State of New Mexico
ENVIRONMENT DEPARTMENT
DOE OVERSIGHT BUREAU
P.O. Box 1663, MS/J-993
Los Alamos, New Mexico 87545

Subject: Observations and recommendations regarding BMP implementation and maintenance at TA-54, Area G & TWISP area

Enclosed is a summary of our evaluations. Included are a site map, photo documentation, observations, recommendations, and data from one split sample of sediments captured by silt fencing below the TWISP Pad 4 area.

Photo 7 People standing on platform are inspecting location where erosion has diverted flows around gage.

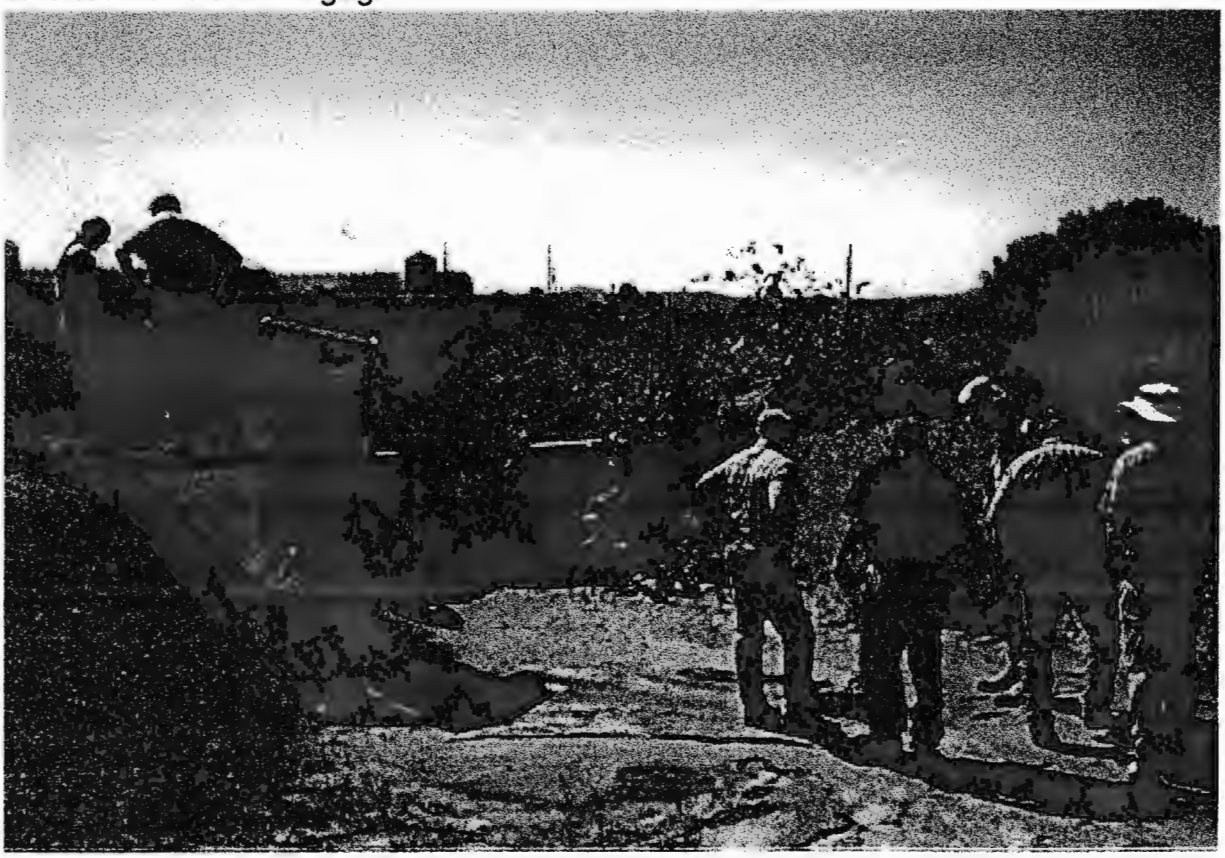
Photo 6 is looking south-south-west from rock apron below Building 375 across natural drainage channel mentioned in previous recommendation. Soil pile in right center of photograph is sediment previously collected by silt fence. Silt fence was removed due to storm damage and soil stockpiled prior to planned silt fence replacement. Bare soil below rock apron is Pit 24 cover. Eroded gage station shown in Photo 7 is located at head of drainage down-gradient from soil pile.

- The silt fence network should be extend to just below regraded cover over Pit 24.
- The breached gage station in drainage should be repaired and utilized as a storm water runoff detention basin.

Note: By August 4, the breached gage station had been repaired by positioning four loads of large rock in and below the breach. The silt fence network was also extended below Pit 24 (Photos 15 & 16).

Photo 8 Looking southeast from rock apron below Building 375

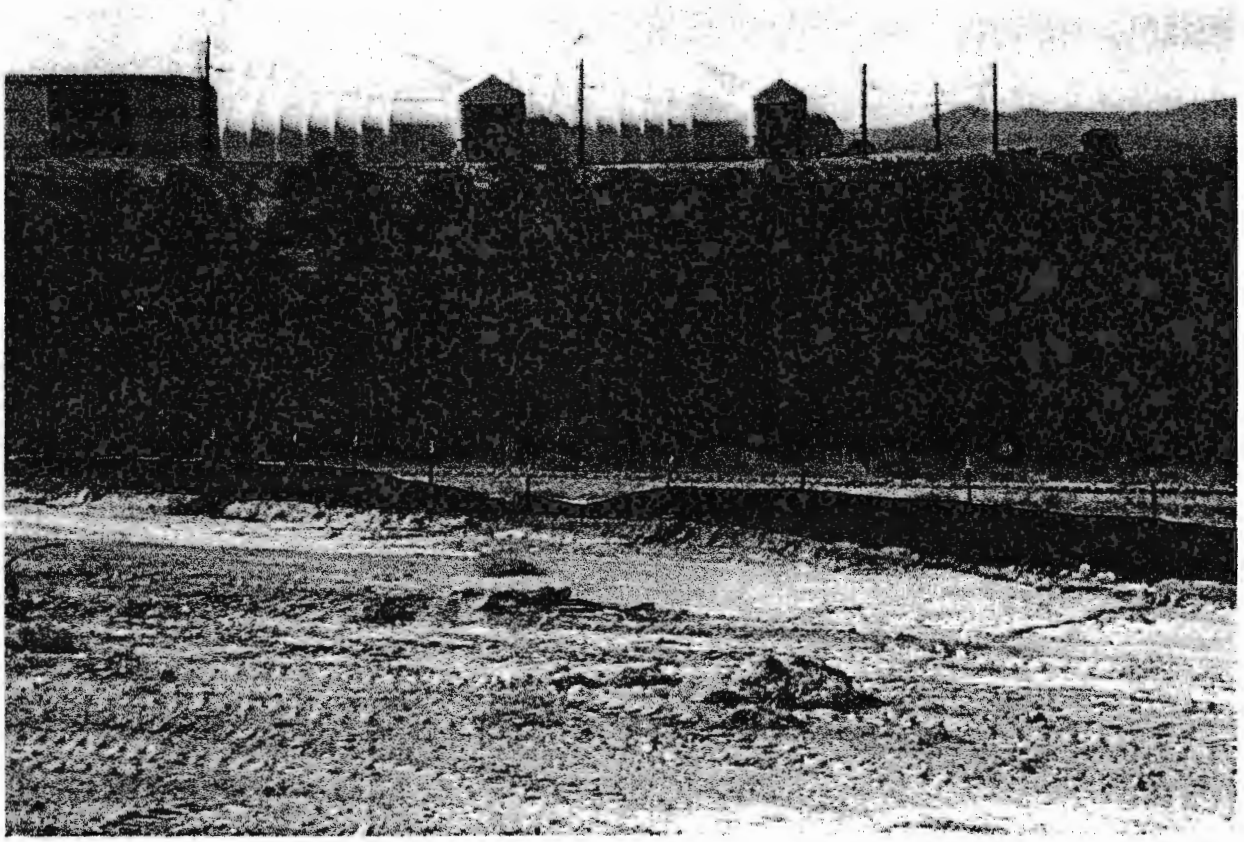
Photo 8 was taken from below cobble apron at Building 375, down-gradient from Pit 24, looking southeast at silt fence. Note that soil has been graded into a pile along base of silt fence. This practice reduces the silt fence's capacity to trap sediments and places excessive stress on the fence under storm water loading. Photo 9 shows where water has breached under this silt fence. Main drainage (canyon) below silt fence and TWISP container storage domes A, B, and C in background leads to storm water monitoring station 3.

Photo 11 Looking south, monitoring station G-3 located in drainage (in background), at site boundary

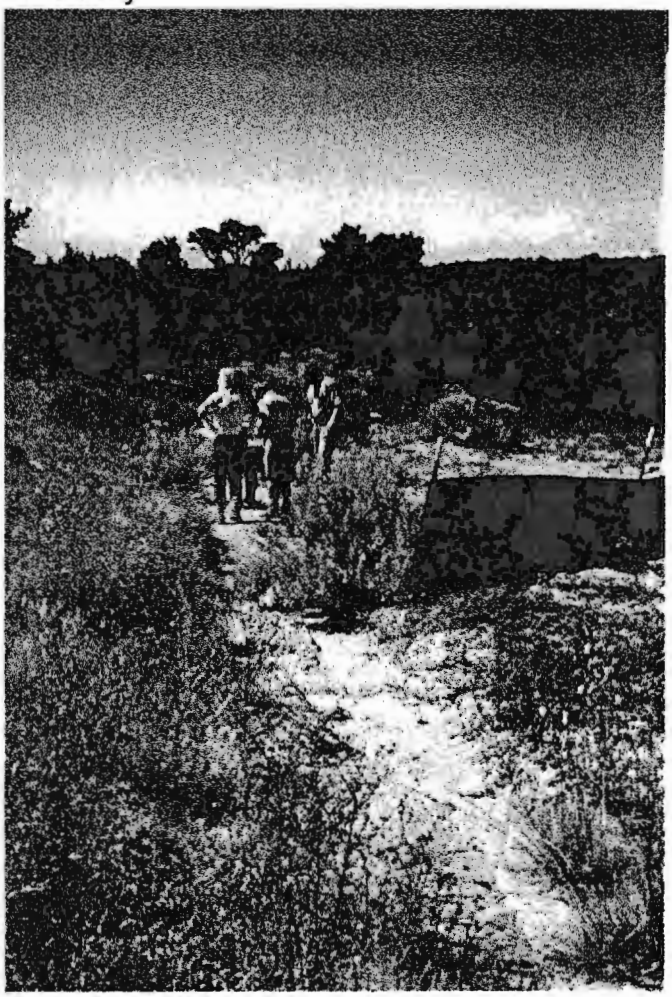
The drainage in Photo 10 bypassed downstream silt fences (Photo 11) until it left the TA-54 facility near storm water monitoring station G-3. The silt fence at G-3 was breached and the monitoring station was buried during the June 17, 1999 storm event (200 year rain event).

A series of multiple silt fences in this reach would slow runoff, drop sediments, and help protect downstream silt fences and detention basins.

Note: By August 4th, multiple silt fences had been installed in this drainage (Photos 15 & 16).

Photo 17 TWISP Pad 4 TRU waste retrieval operations

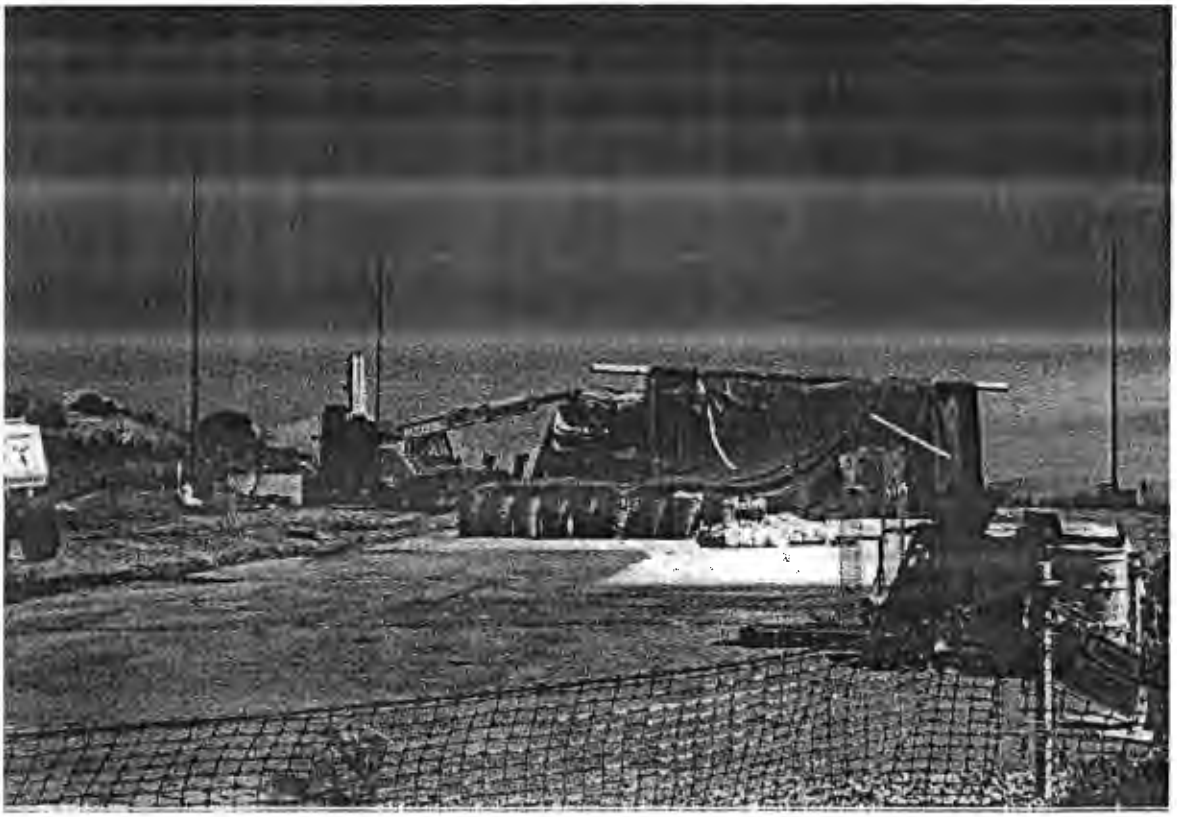
Bermed soil to right of loader is intended to direct runoff towards left in into silt fence shown in Photo 19.

The orange fence is at the heavy equipment access to Pad 4 Area. The coarse gravel berm under orange fence acts as run-off control (traps fine sediment and directs runoff to silt fence in Photo 19) yet allows heavy equipment passage.

- The berm of soil (Photo 17) could be replaced with temporary, movable barriers. ESH-18 has tested several types of barriers (e.g., Triangular Silt Dike, Straw Wattles) that may be appropriate to use in this instance.
- The Triangular Silt Dike barrier may provide better protection than the coarse gravel berm used at the heavy equipment access.
